City of Mississauga Department Comments

Date Finalized: 2023-10-04	File(s): A313.23 Ward: 9
To: Committee of Adjustment	
From: Committee of Adjustment Coordinator	Meeting date:2023-10-12 1:00:00 PM

Property Address: 7271 Windbreak Crt

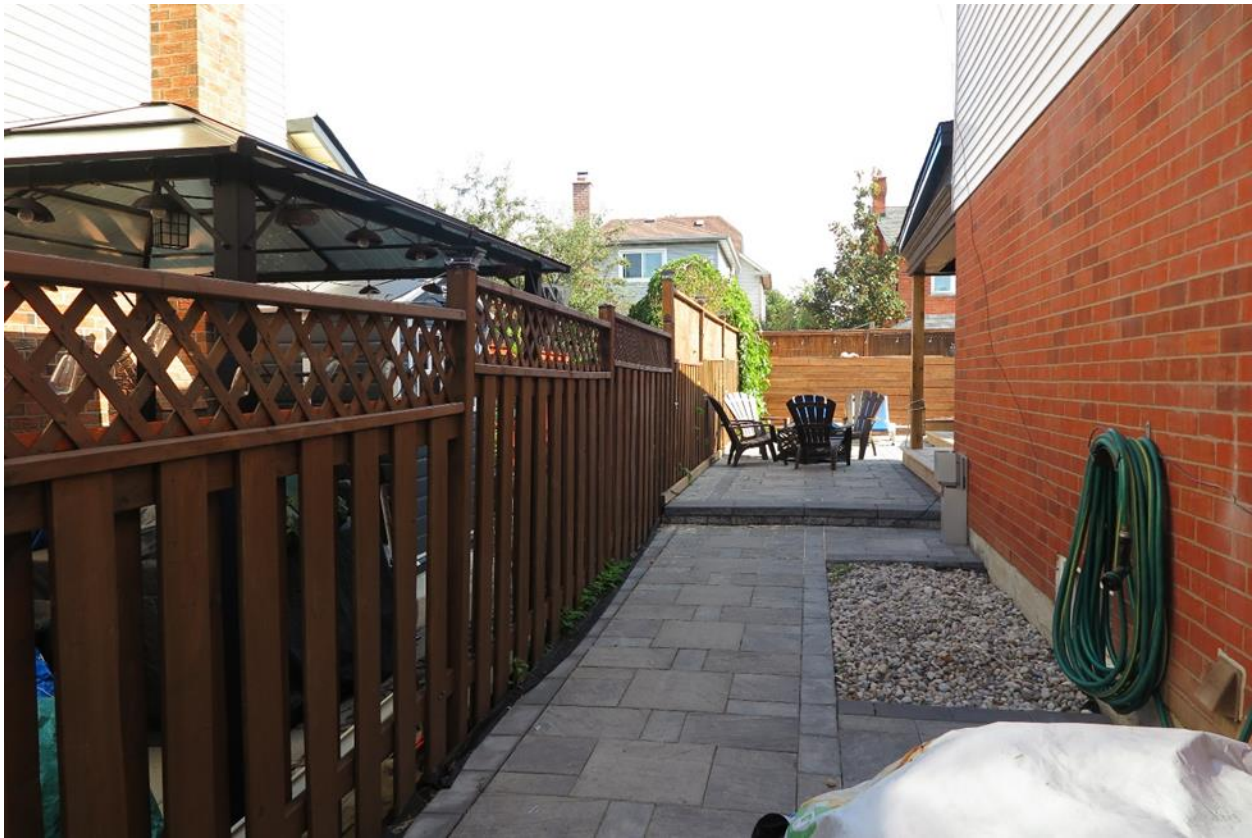
Enclosed for Committees easy reference are a number of photos depicting the subject property, in particular the areas where the variances for the pool setbacks, deck and shed are being requested. From our site inspection and the attached photos it is evident that this property has a rear to front drainage pattern which means that drainage is directed to the front. The applicant has put gravel in the area between the pool and the abutting neighbour to the rear and any drainage from this area can adequately be directed to the front causing no drainage impacts to the neighbour to the rear and in this regard we have no objections to Variances # 1 to 3.

Along the south-easterly property limits, for Variances # 4 and 6 we do acknowledge that the applicant has provided a very minimal setbacks, however, we also note that the abutting property owner has also constructed a structure with a very minimal setback. In this regard both property owners have impacted the drainage pattern, nevertheless, with the significant slope towards the front of the dwelling we do not foresee a drainage concern.

For Variance # 5, which deals with the setback from the interlock stones on the left side of the property, we do not foresee any drainage concerns as this area is free and clear of obstructions and there is a significant slope to the front of the property.
